CHEVROLET—CENTRAL OFFICE

TECHNICAL SERVICE BULLETIN

SUBJECT: 1957 CORVETTE
SPARK PLUG
RECOMMENDATIONS

BULLETIN NO.: DR #295

Corvette Engines with AC 46-5 Plugs

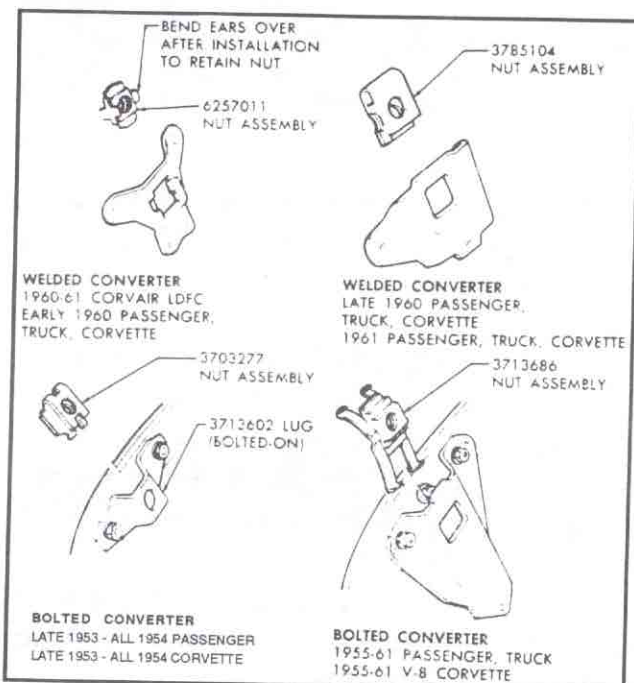
170 Corvettes were built during period 3-29 to 4-9-57 with AC 46-5 Plugs installed.

Serial # E57S-103098 to 103268.

These plugs should be changed to AC-46 due to spark plug boots not fitting the AC-46-5 plugs properly.

Notice that the insulators on the 46-5 are smooth type, same as '53 - '56.
